**Bureau of Project Delivery
Bridge Design and Technology Division**

No. 048
March 9, 2018

BRADD v3.2.4.0: Integral Abutments w/ Staged Construction; Abutment Details, Barrier Overhangs Abutment – Patch Available

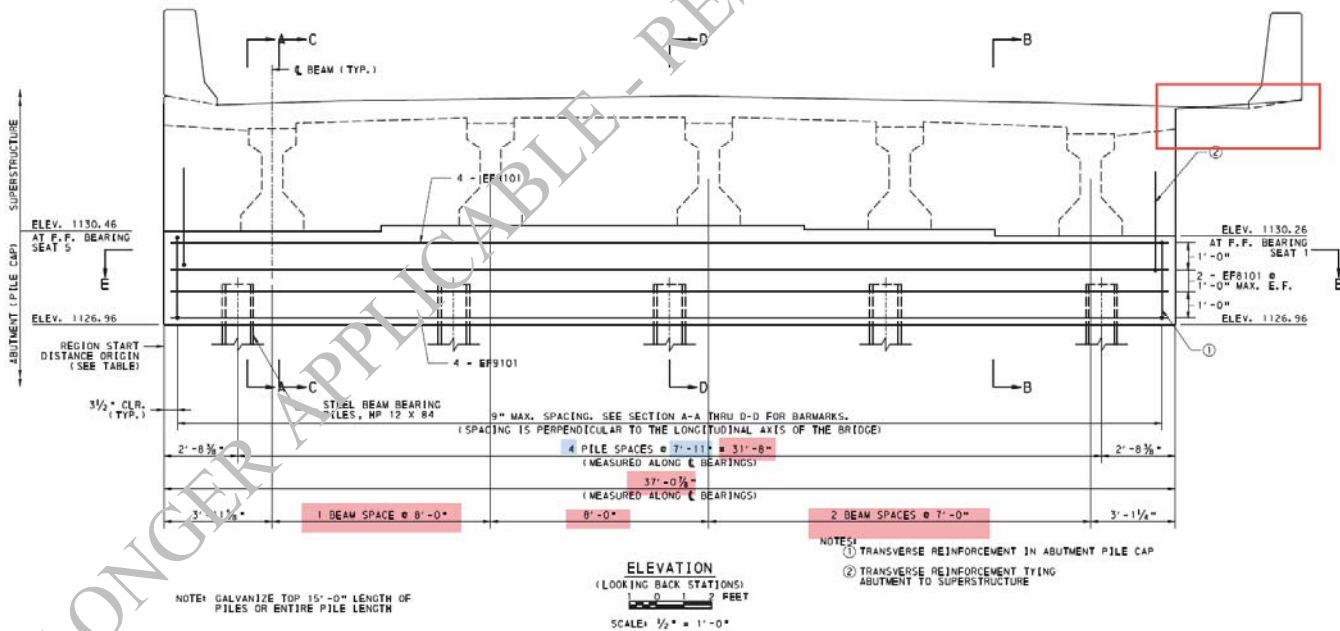
Under certain conditions BRADD version 3.2.4.0 details some integral abutment details incorrectly. For a skewed bridge with integral abutments and a staged construction joint with different beam spacings, BRADD incorrectly details the abutment length perpendicular to the C.L. of bridge instead of parallel to the C.L. of bearing. As a result, on the “Abutment Elevation” detail, the right barrier is detailed overhanging the right end of the abutment and the beam spacings shown are incorrect.

The details shown below were taken from a BRADD job with a 60 degree skew.

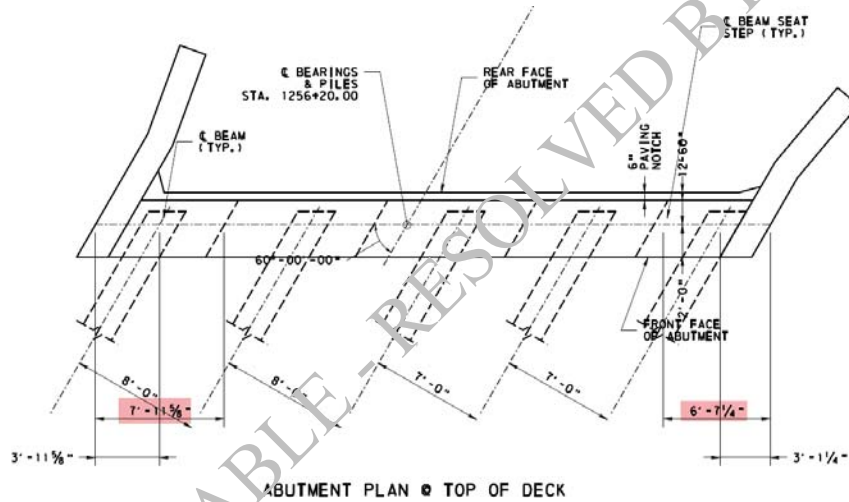
The overall dimension of the abutment length (measured along the CL Bearing) needs to be revised and some dimensions shown on the “Abutment Plan @ Top of Deck” detail, and the “Pile Cap Transverse Reinforcement Information” table are also impacted. The user input of Number of Piles and Pile Spacing will need to be adjusted accordingly. These pile spacings are displayed on a number of details.

The beam spacing has not been expressed along the C.L. Bearing and all the highlighted numbers above (between the two fascia beams) need to be increased by a factor of 1.155 ($1 / \sin(60^\circ)$)

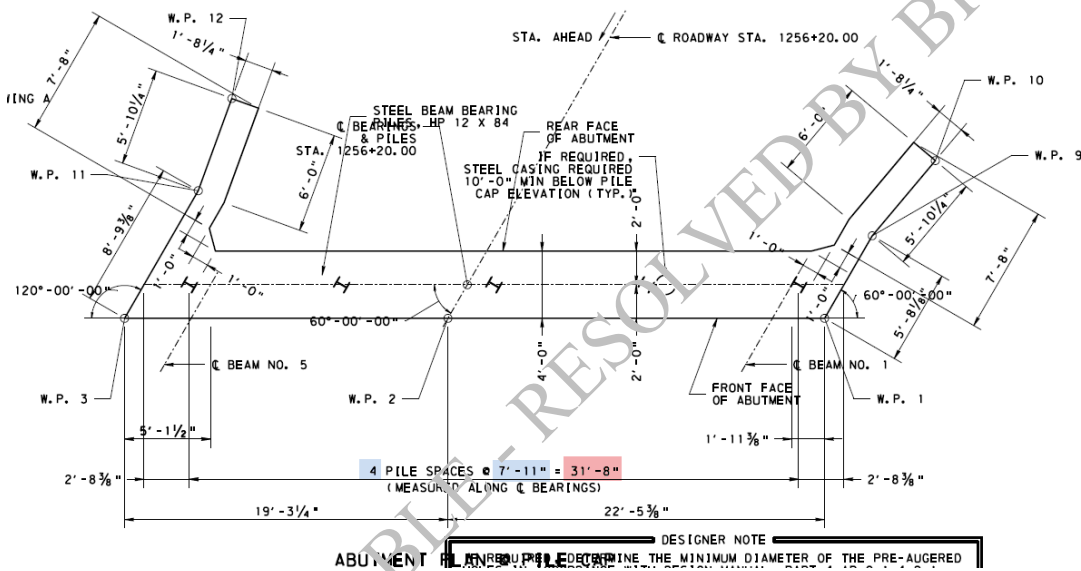
The overall pile spacing dimensions (measured along the C.L. Bearing) shown on the “Abutment Plan @ Pile Cap” detail also needs to be revised.

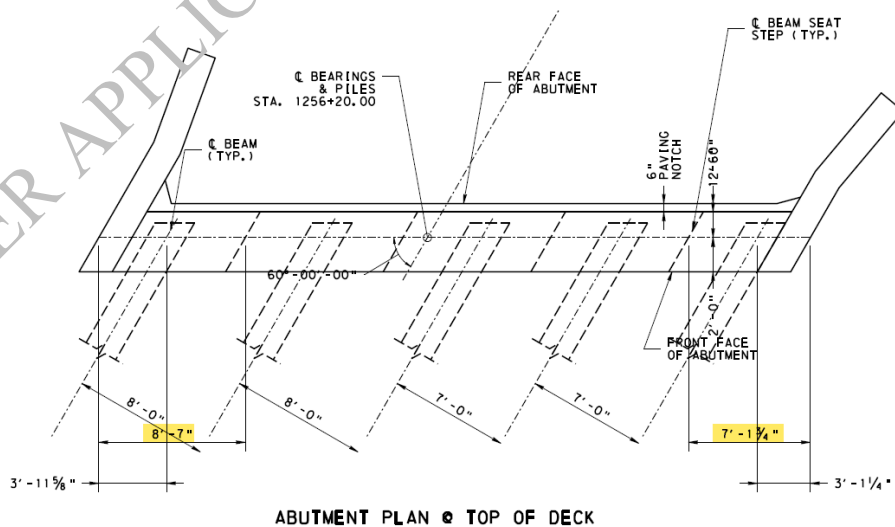
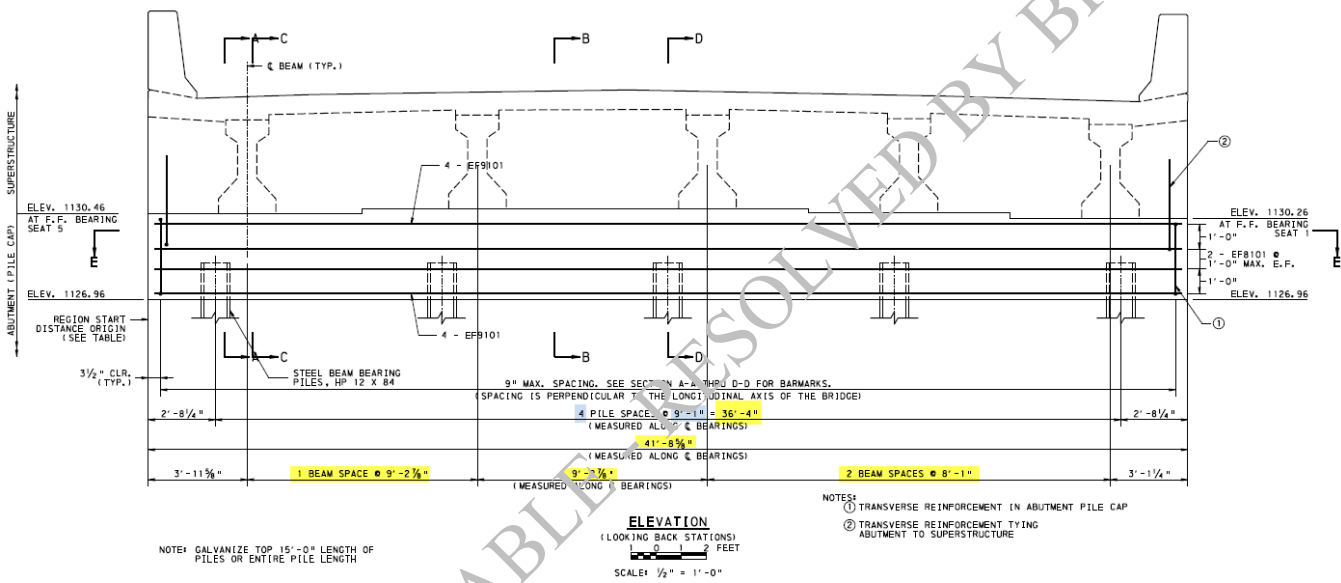
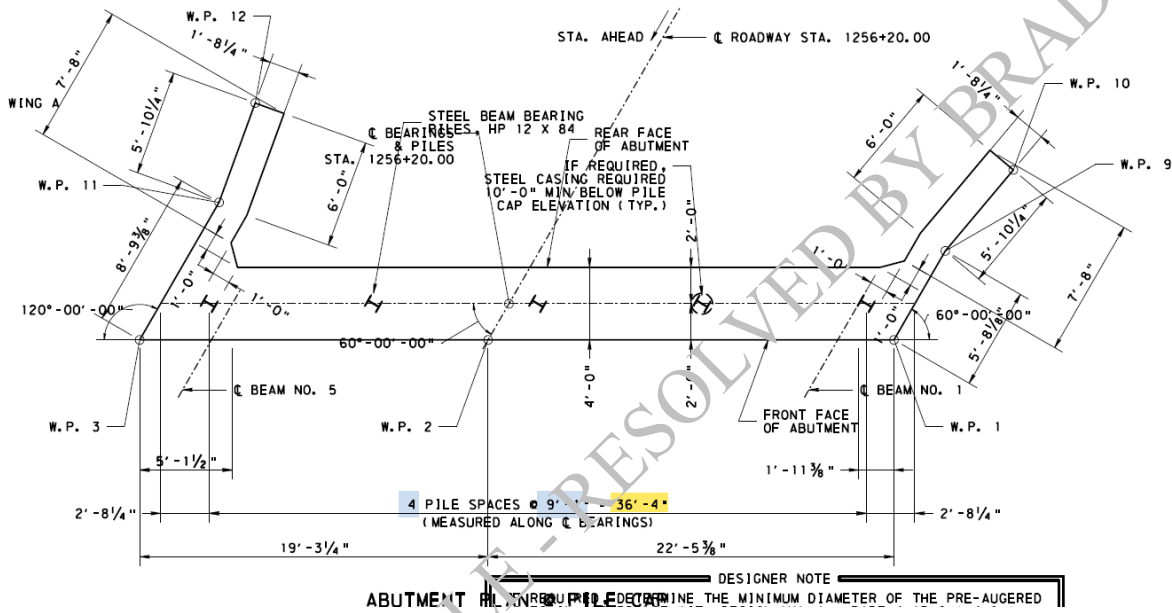
The details shown below display the corrected dimensions:

A fix for this problem is available in BRADD patch version 3.2.4.1 which can be downloaded for free as a patch from the BRADD website.
